Keck I Cassegrain ADC: Detailed Design Review

UCO/Lick Observatory

21 May 2004

ADC Merit

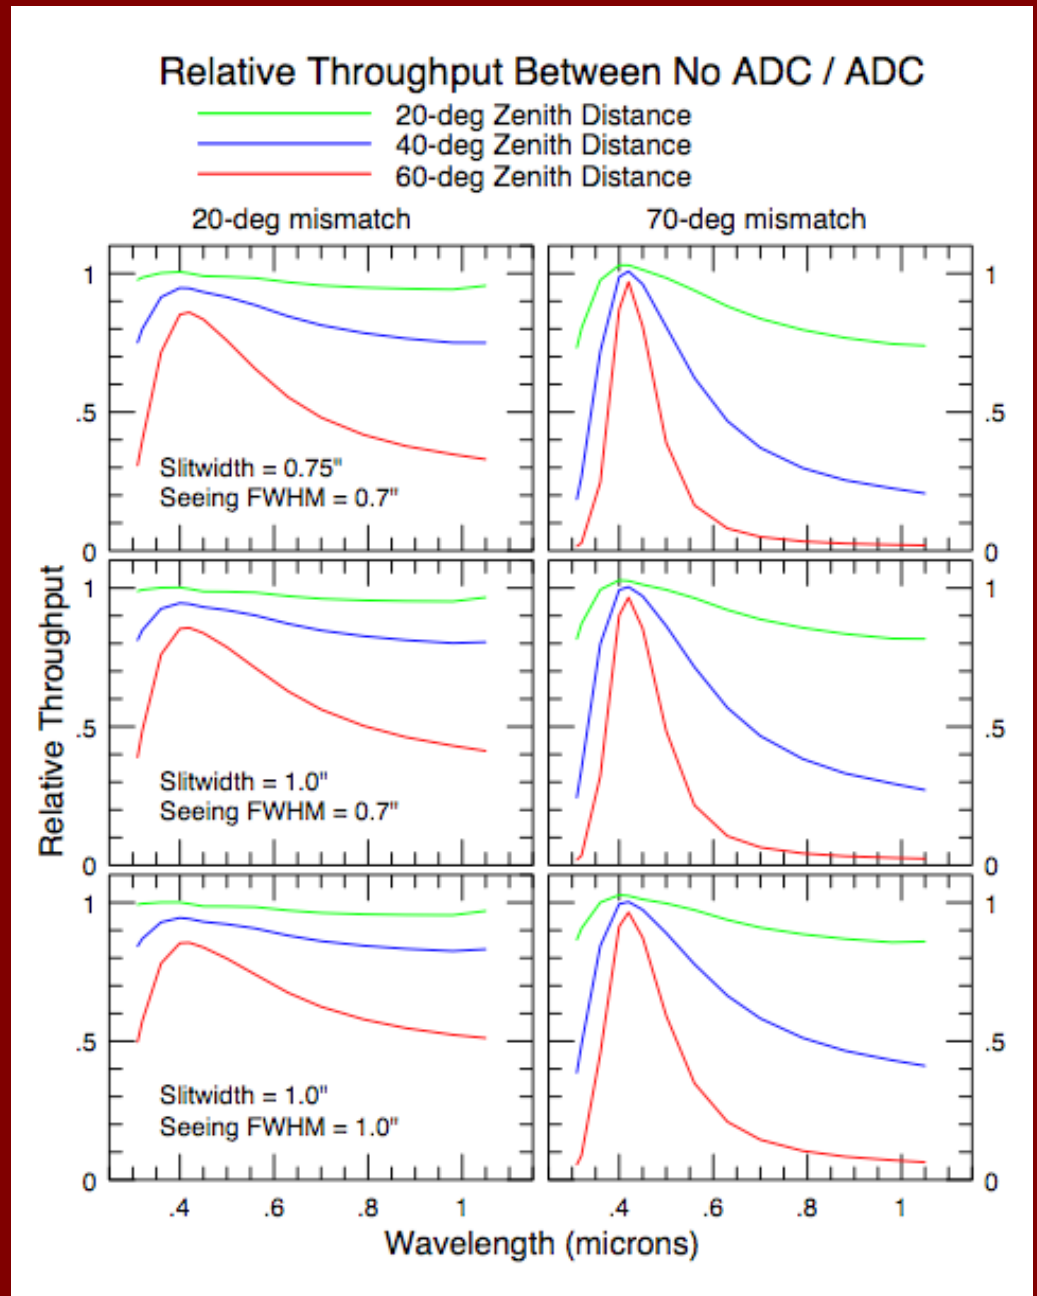
- 1. The ADC science gains should be quantified in “typical” configurations detailing the performance of LRIS without the ADC; with a perfect ADC; and LRIS with the predicted performance of the ADC as designed.*

- Relative throughput without ADC for well-aligned and poorly-aligned slitlets (*l-r*), for a variety of conditions (*top-to-bottom*) and elevations (*colors*).
- Report to the SSC included as Appendix 1.

Sol-Gel + MgF_2 : Adhesion Tests

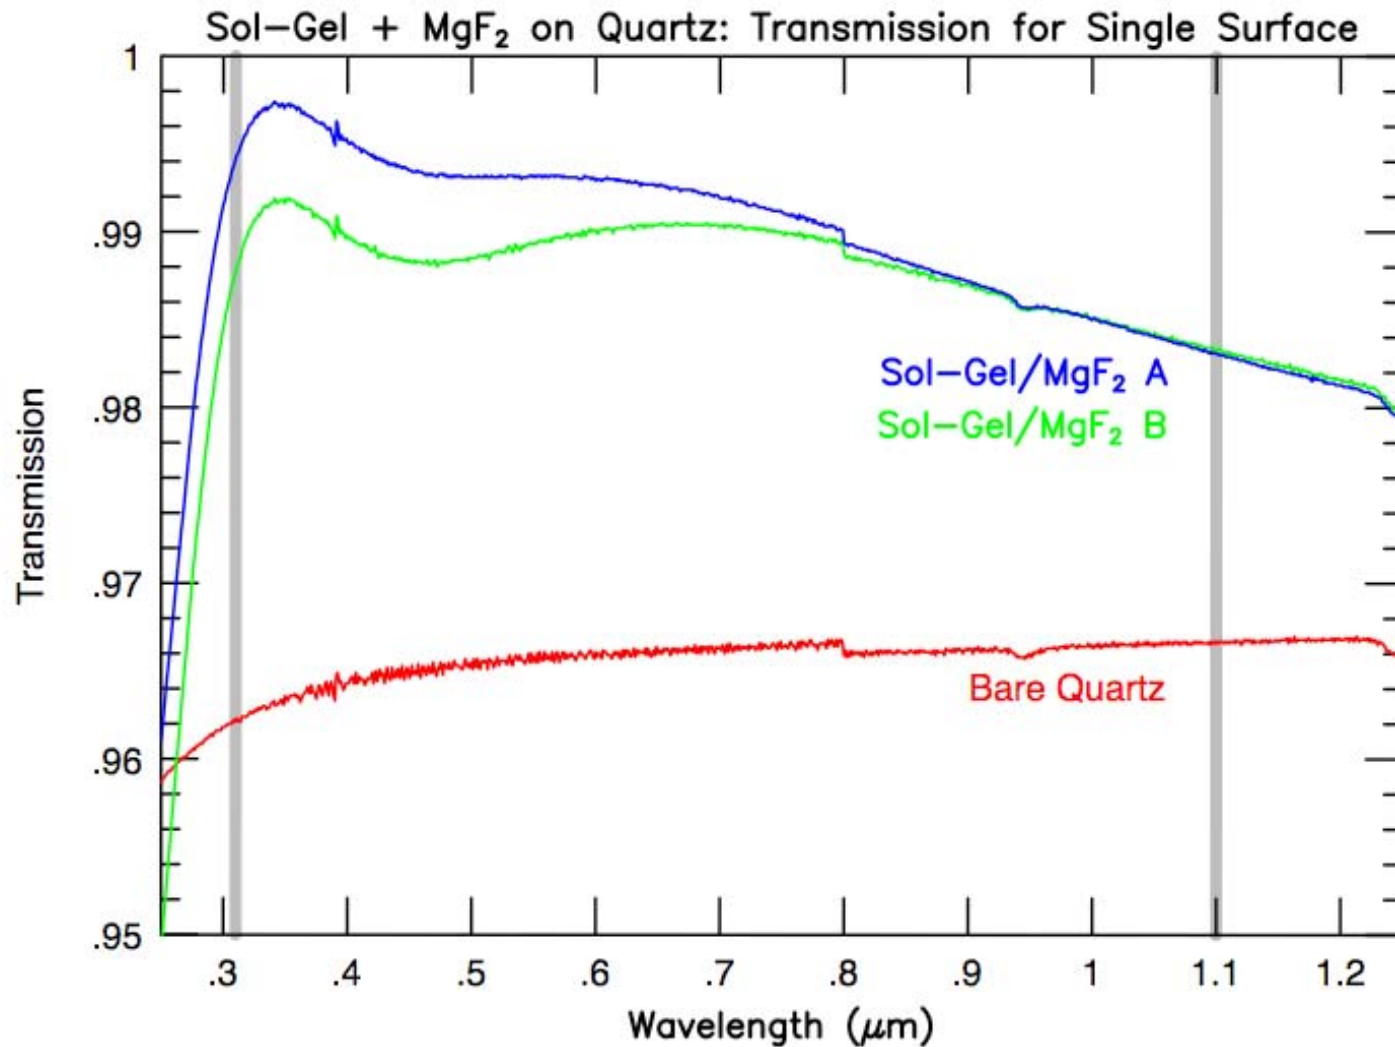
4. Additional attention should be given to characterizing the coatings and confirming the transmission that will be achieved. In particular test coatings should be done to confirm the transmission and to evaluate compatibility with various cleaning procedures.

5. The field flattener from the original HIRES dewar should be removed after the upgrade is complete and sent to Livermore for measurement of transmission. The original and new transmission curves can then be compared to look for aging effects. Other groups should also be contacted for information about coating durability and aging effects.

- Poor adhesion of Sol-Gel to MgF_2 remains serious problem!
- Possible solution: *deposit a very thin bond layer of silica (or ... ?) over MgF_2*

- Deposited MgF_2 on 2"× 1/8" quartz samples
- Overcoated with thin “bond” layer
- Jim Stilburn (DAO) spin-coated w/ Sol-Gel
- Results of abrasion/adhesion tests:
 - Bare MgF_2 : Poor (“comes right off”)
 - ~40 Å of SiO_2 or SiO_x : Adheres as well as to bare glass
 - ~40 Å of Al_2O_3 : “tough as nails”

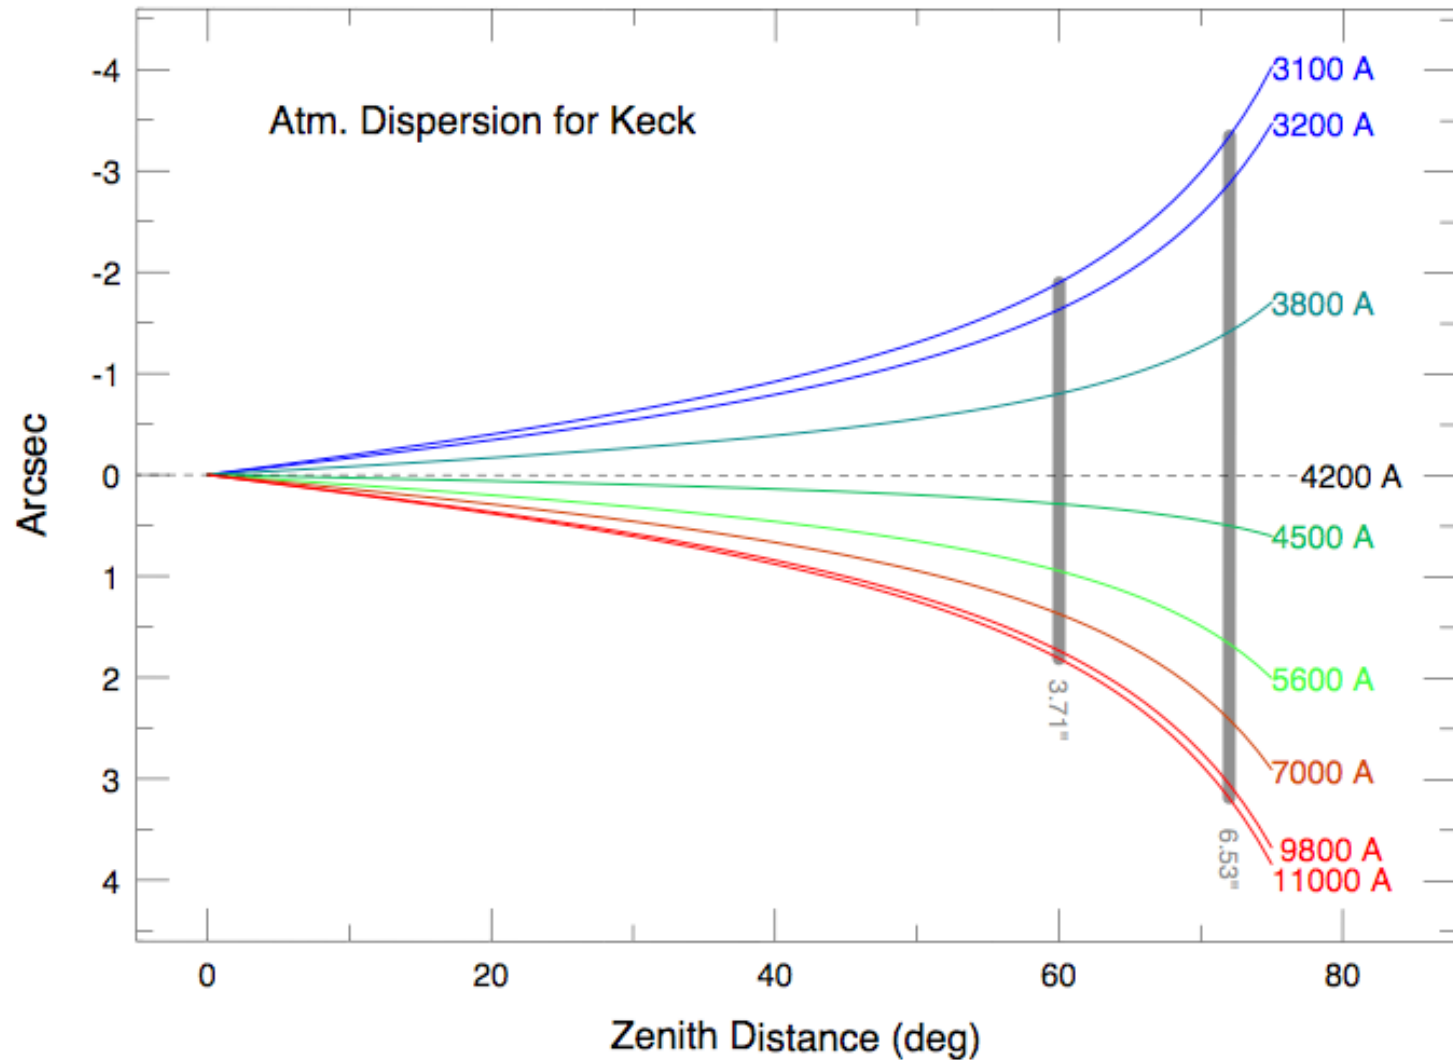
7. Any software GUI designs required by the ADC should be defined in the detail design phase.

Ans. GUI designs are being developed with CARA input, and acceptable designs exist (Sect. 4.4.4)
